# HISTORIC AND DESIGN REVIEW COMMISSION

May 18, 2022

**HDRC CASE NO:** 2022-258  
**ADDRESS:** 4002 ROOSEVELT AVE  
**LEGAL DESCRIPTION:** NCB 7464 BLK 2 LOT 1 HARLANDALE MEMORIAL STADIUM SUBD.  
**ZONING:** I-1, H  
**CITY COUNCIL DIST.:** 3  
**DISTRICT:** Mission Historic District  
**APPLICANT:** Suresh Modadugu  
**OWNER:** Juan Hinojosa /HARLANDALE I S D  
**TYPE OF WORK:** Partial demolition, new construction of press box, seating, field house and site buildings, signage, site repairs  
**APPLICATION RECEIVED:** April 28, 2022  
**60-DAY REVIEW:** Not applicable due to City Council Emergency Orders  
**CASE MANAGER:** Edward Hall  
**REQUEST:**

AS-101  
ARCHITECTURAL SITE  
PLAN

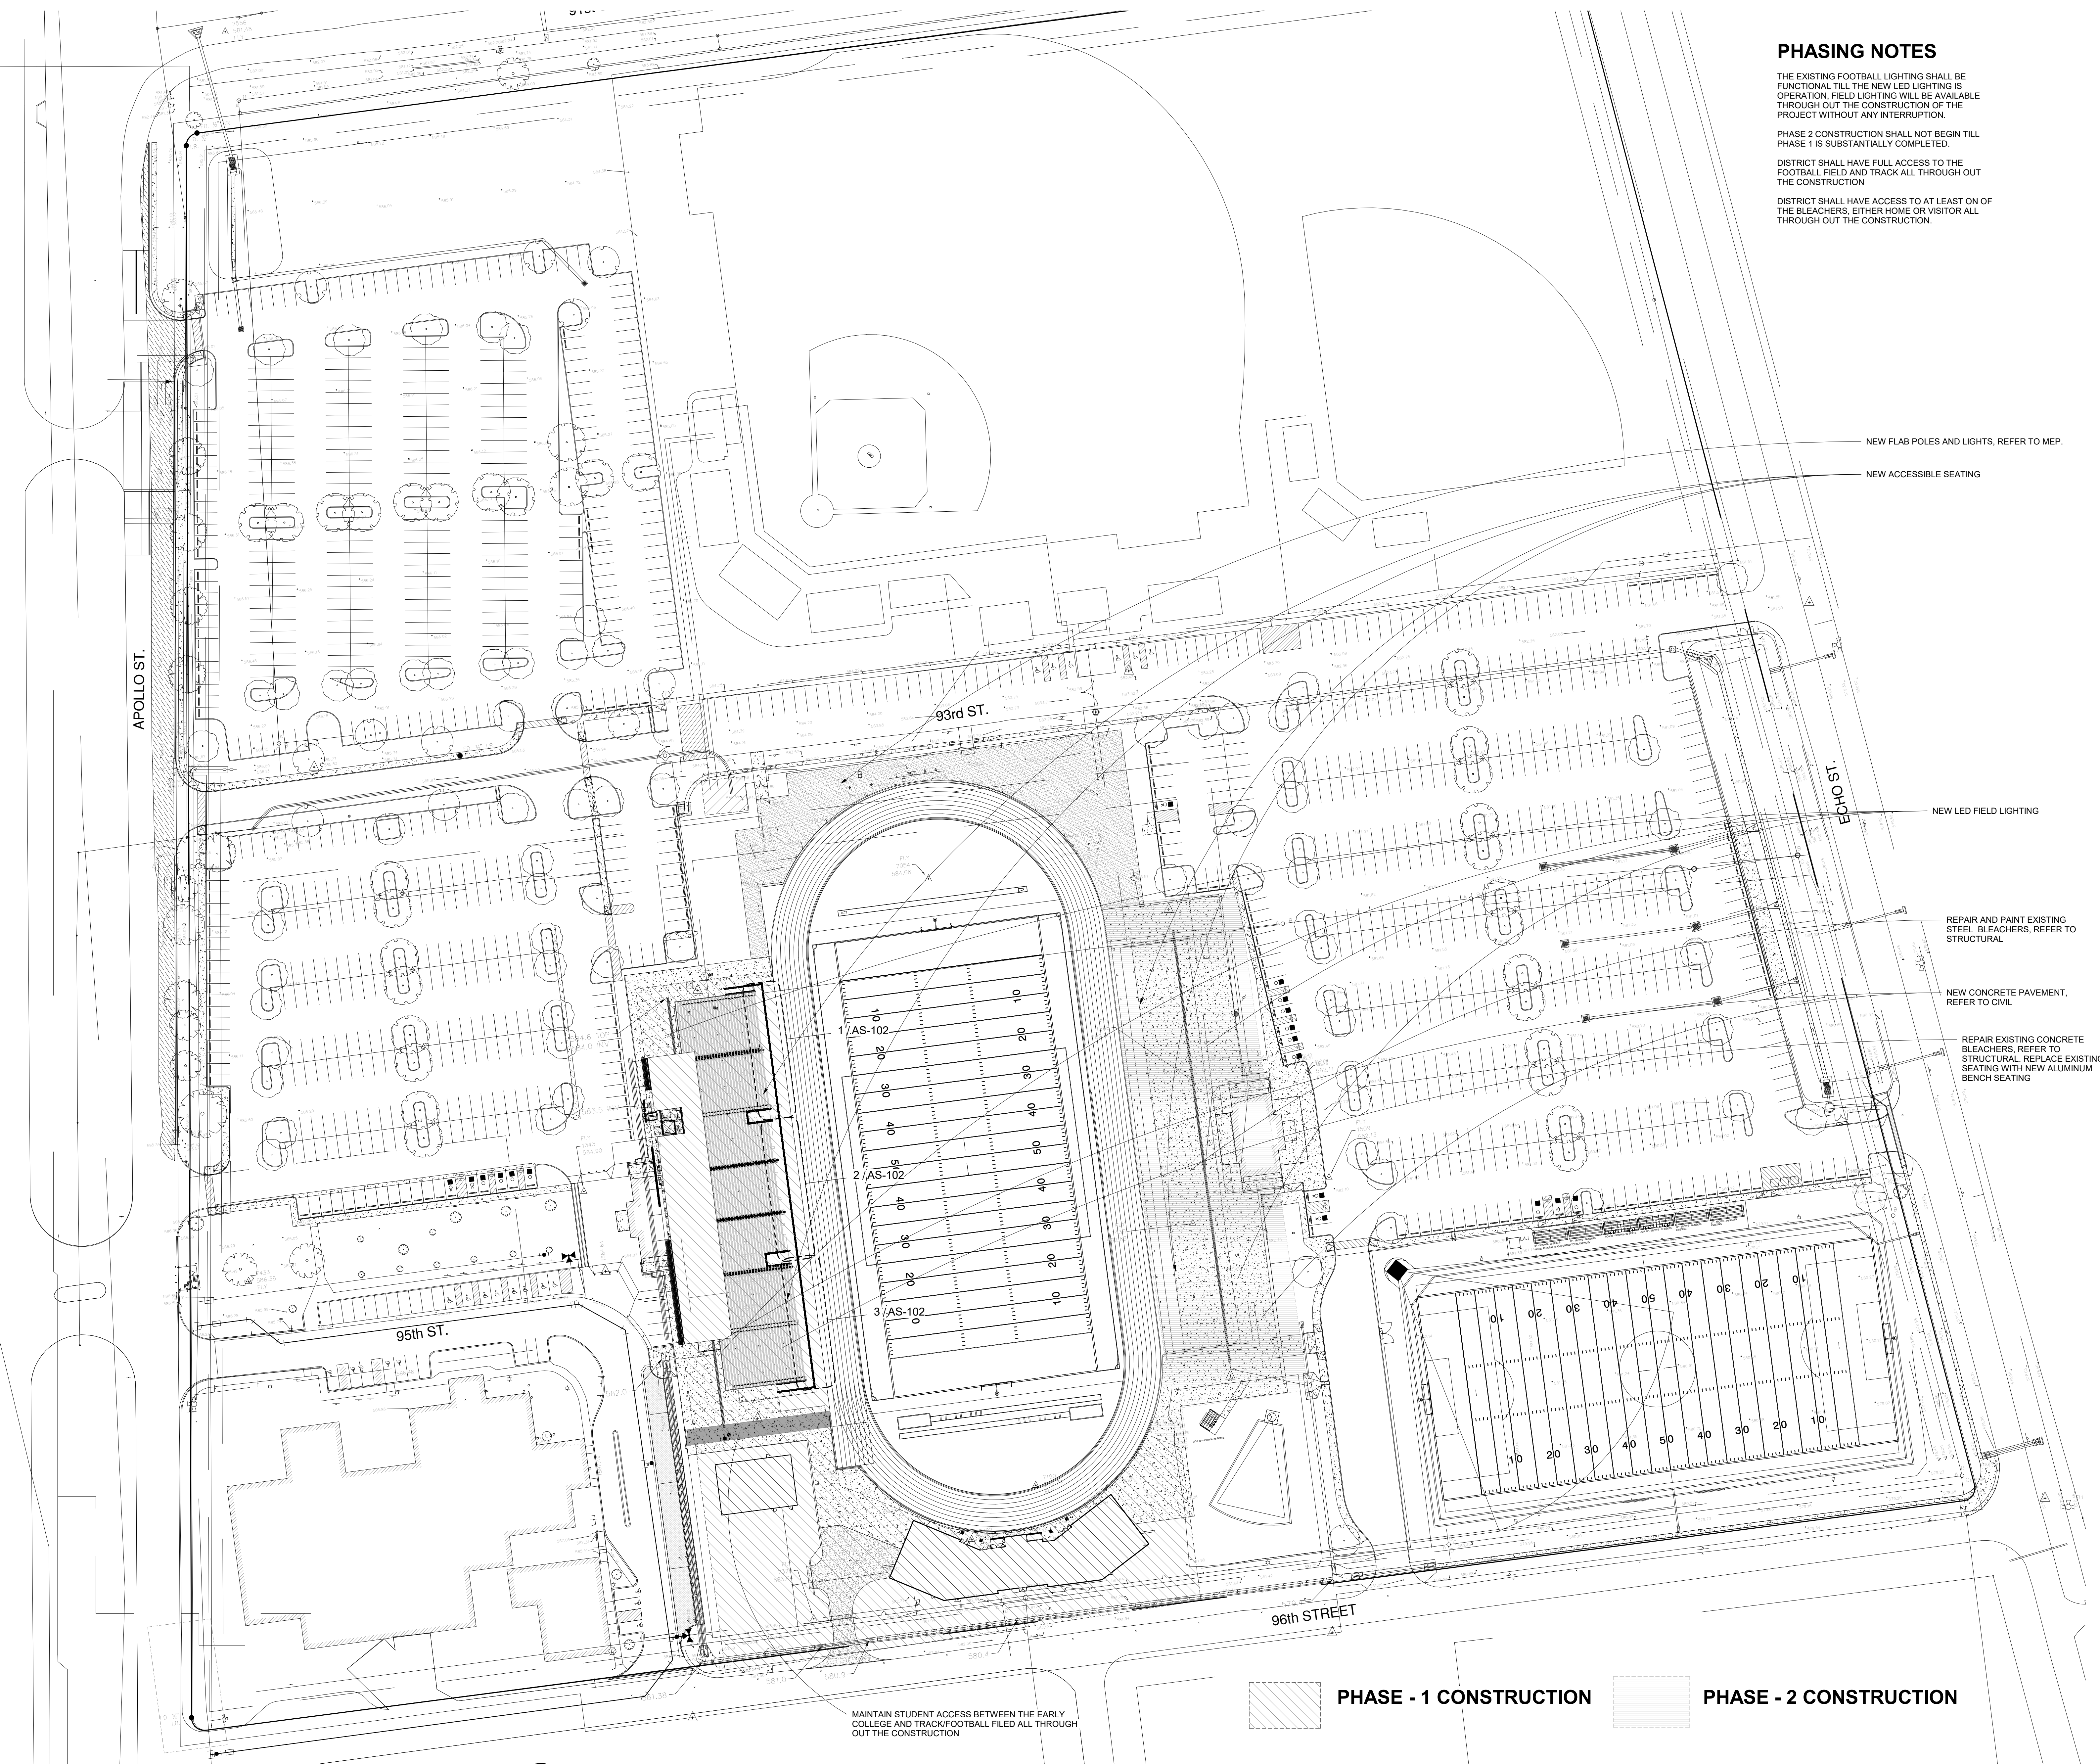
- f. FIELD HOUSE/SITE BUILDINGS (Site Design) – The existing arrangement of buildings on site are currently configured in a campus setting, which is recommended by the Mission Historic District Design Manual. The applicant has proposed to maintain this site arrangement. This is consistent with the Design Manual.

A-201P  
PRESS BOX - EXTERIOR  
ELEVATIONS &  
ENLARGED ELEVATIONS

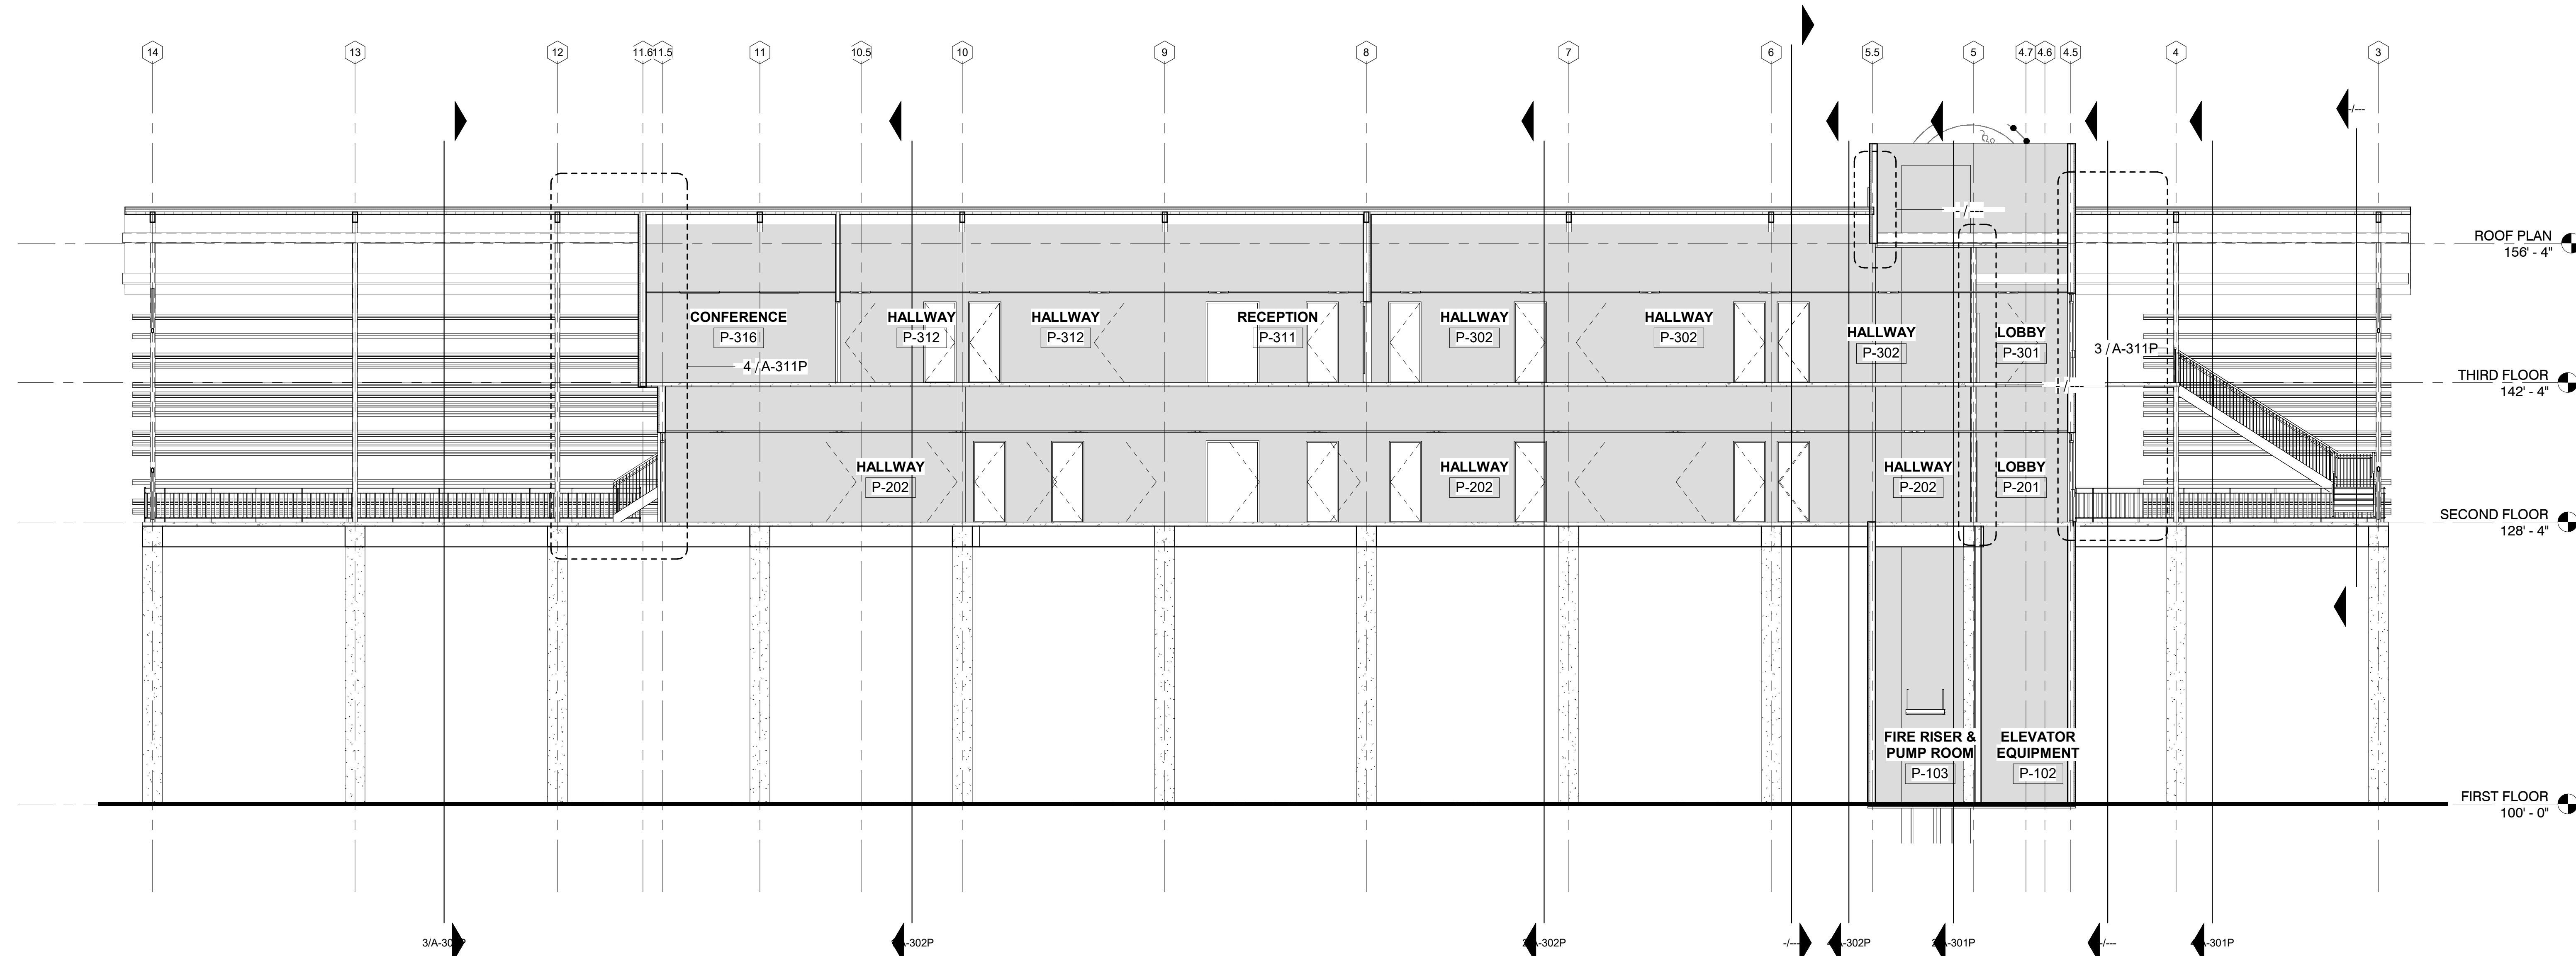
- d. PRESS BOX/ADA SEATING – The applicant has proposed to construct a new press box building and add ADA accessible seating to the west seating area. The proposed new press box will feature perforated metal panels, metal façade panels and curtain wall glass. Generally, staff finds the proposed design to be appropriate and consistent with the Mission Historic District Design Manual.
